Service Bulletin No:	13-006
Group:	27-Electrical & Meters
Issue Date:	07-05-2013

SUBJECT:
CORRECTION OF WORKSHOP MANUAL FOR 2011, 2012 and 2013 CONVENTIONAL MODELS
(CORRECTION OF DIAGNOSIS PROCEDURE OF CAN COMMUNICATION LINE)

Example: Manual No. S7-UNAE09A Page DN06-16

2. INSPECTION OF THE HARNESS BETWEEN AT-ECU/AMT-ECU AND VEHICLE CONTROL ECU (1)

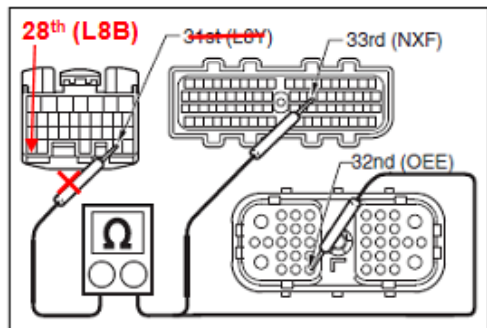
- (1) Check continuity between 33rd (NXF) terminal of the AT-ECU connector (80P) or 32nd (OEE) terminal of AMT-ECU connector (38P) and 31st (L8Y) terminal of the vehicle control ECU connector (32P)

Wrong: 31st (L8Y)
Correct: 28th (L8B)

3. INSPECTION OF THE HARNESS BETWEEN AT-ECU/AMT-ECU AND VEHICLE CONTROL ECU (2)

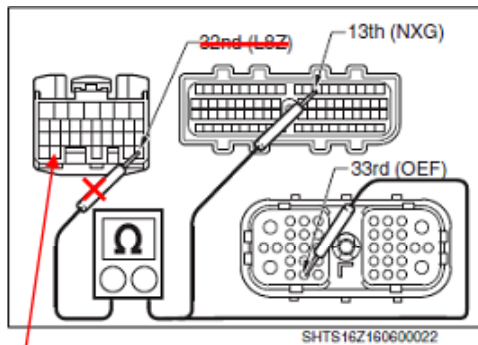
- (1) Check continuity between the 13th (NXG) terminal of the AT-ECU connector (80P) or the 33rd (OEF) terminal of the AMT-ECU connector (38P) and the ~~32nd (L8Z)~~ terminal of the vehicle control ECU connector (32P)

Wrong: 32nd (L8Z)
Correct: 29th (L8C)

29th (L8C)
